Architectural Review Board Staff Report

| Project type: | Amended Architectural Elevations |
| Location: | 719 Spirit 40 Park Drive |
| Description: | <u>Spirit 40 Park, Lot 2 (Corrpak)</u> : Amended Architectural Elevations for a manufacturing building on a 3.03-acre tract of land, zoned “M3” Planned Industrial District located north of Chesterfield Airport Road, west of Spirit 40 Park Drive (17V420124). |

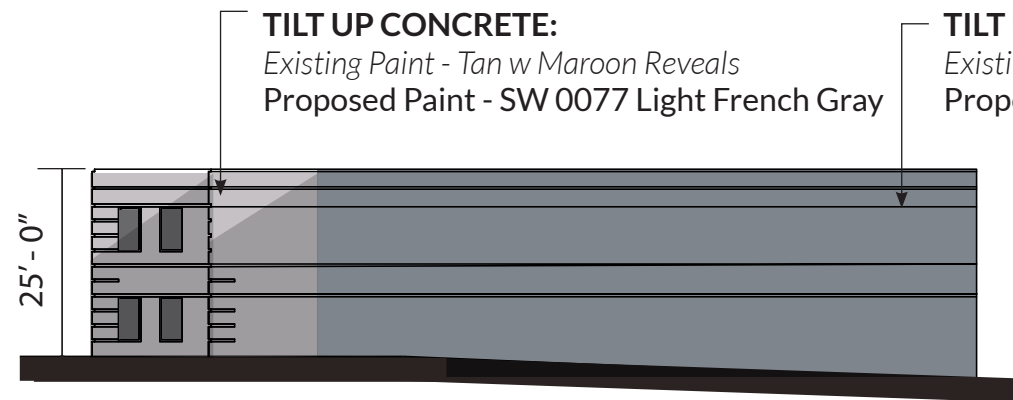
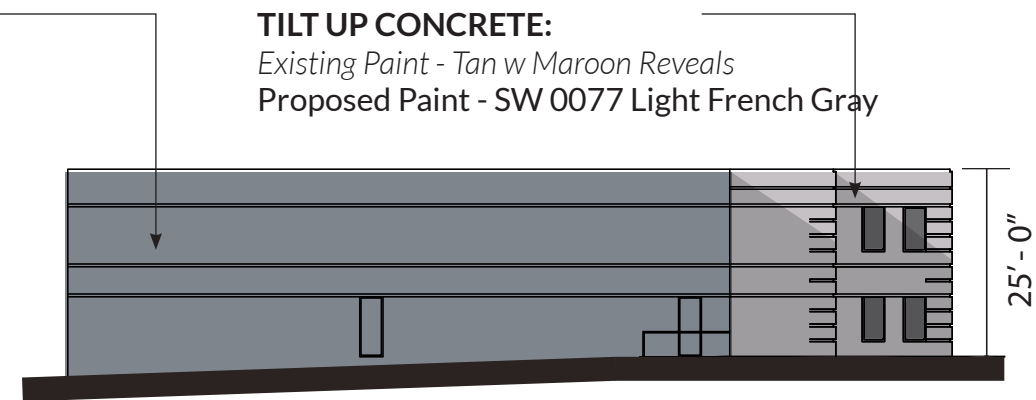
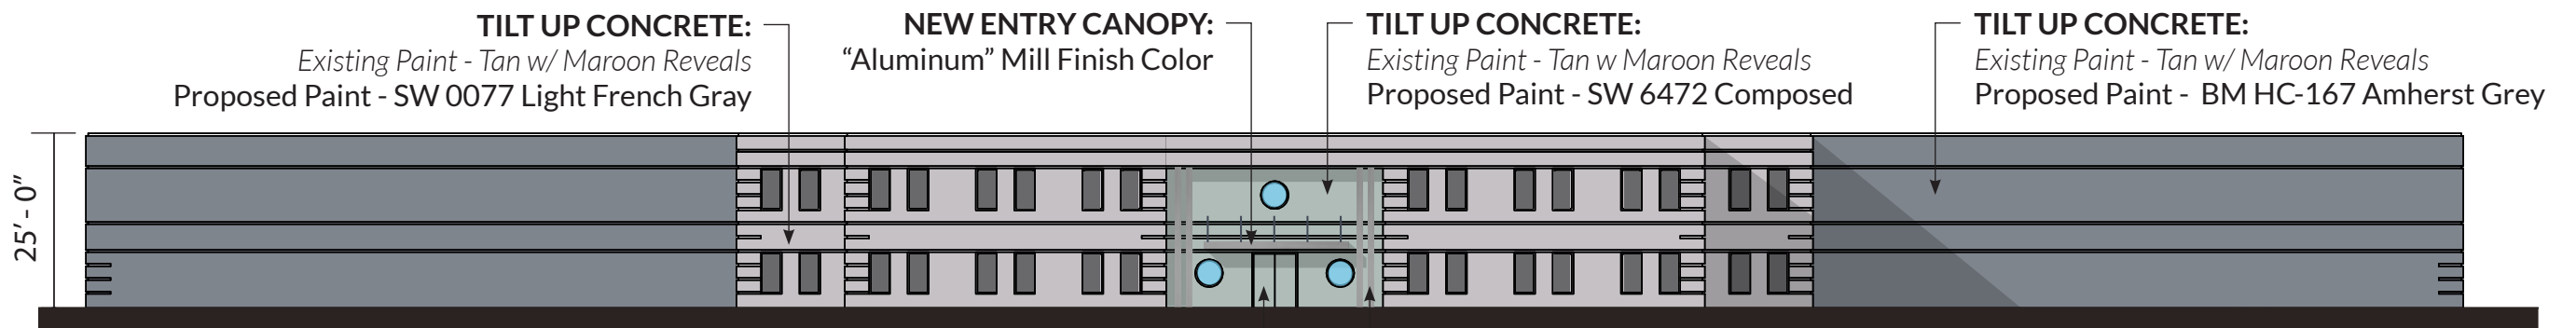
NOTE: All Tilt-Up Concrete wall panels are EXISTING. The scope is to repaint these. All Windows will be replaced with new aluminum/insulated glass units. The Entry doors will be replaced with medium stile aluminum/glass units. We are NOT replacing existing overhead doors or man doors, other than front entry doors.

Entry Perspective View

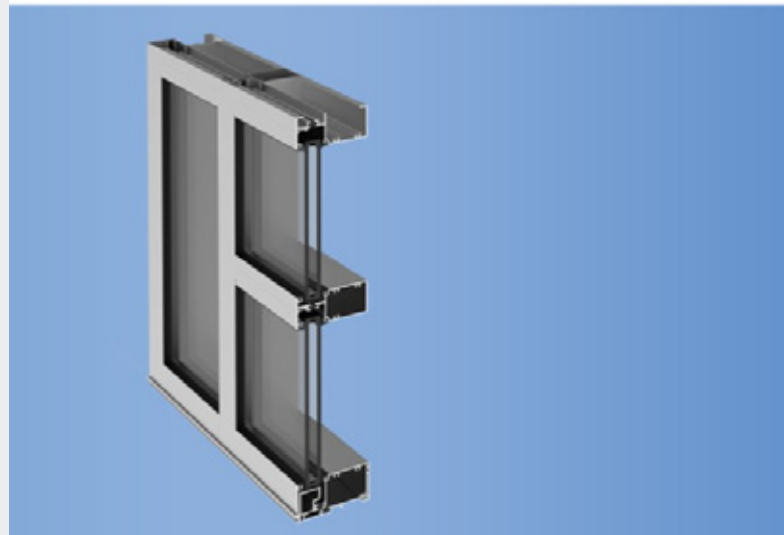
Turquoise columns at Entry removed - pairs of columns at east/west ends remain, repainted neutral color.

New entry canopy, "aluminum" mill finish color.

Existing round windows remain.

New aluminum and glass medium stile doors

Green accent paint at entry

Proposed Replacement Window Details

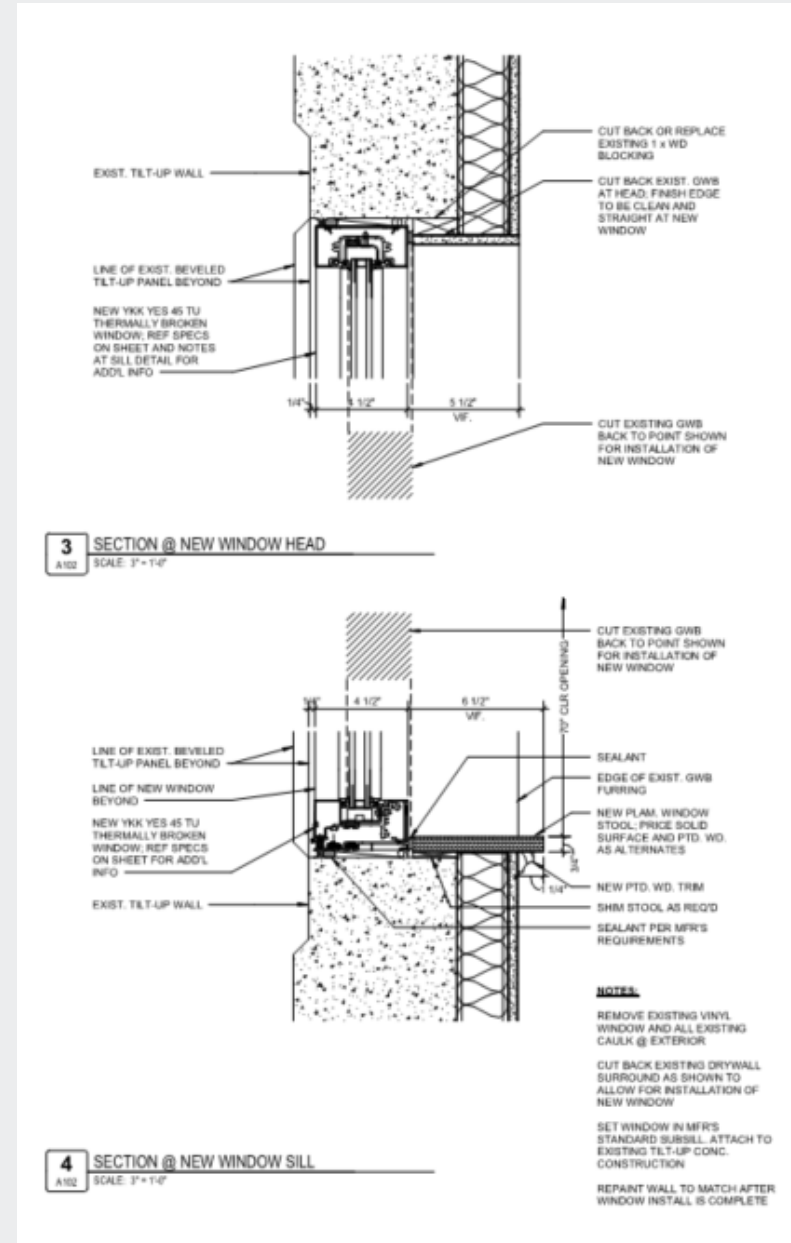
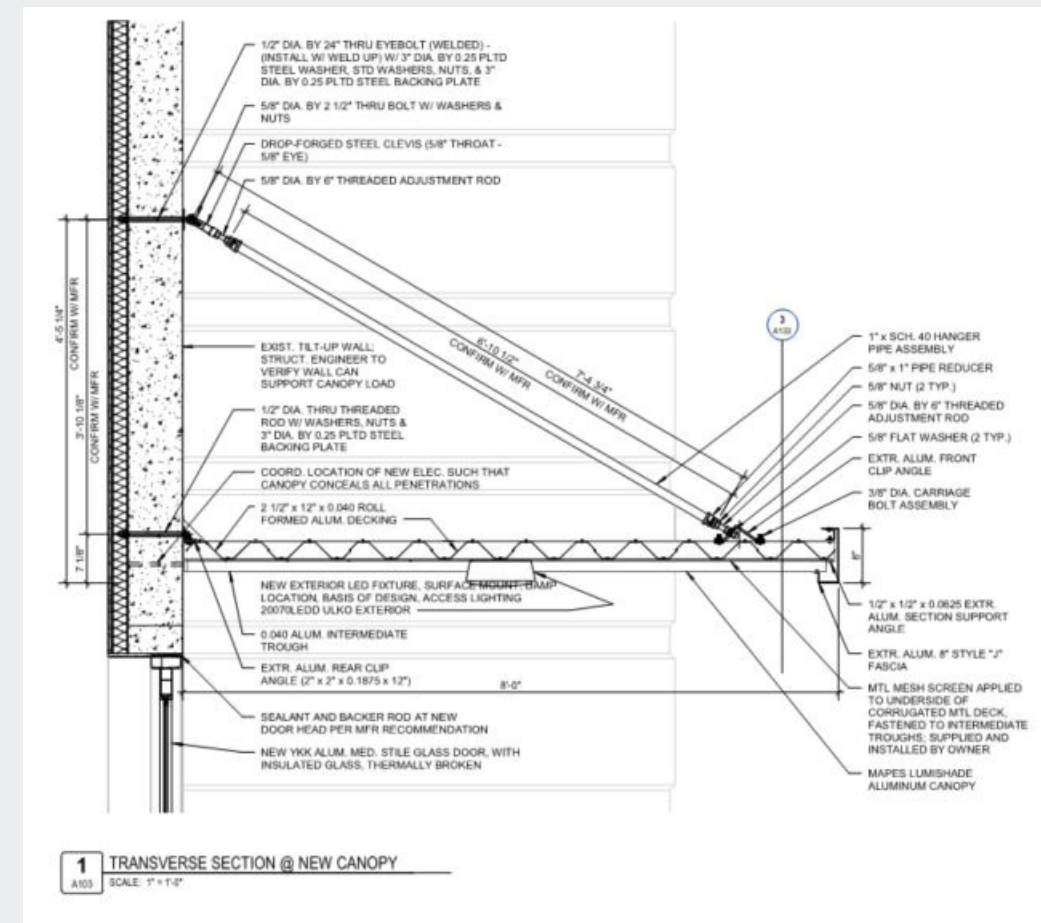
All existing vinyl windows are being replaced with thermally broken, aluminum units (clear anodized finish). the glass will be PPG Solarban "Solargray" units.

Proposed Replacement Window Image
Window shown above from MFGR's Website-
As proposed windows do NOT have horizontal mullions

Existing Windows
Note: we will NOT be replacing with double hung units.
We will NOT be using divided lites.
As proposed will be single pane of glass (IGU) with head, jambs and sill
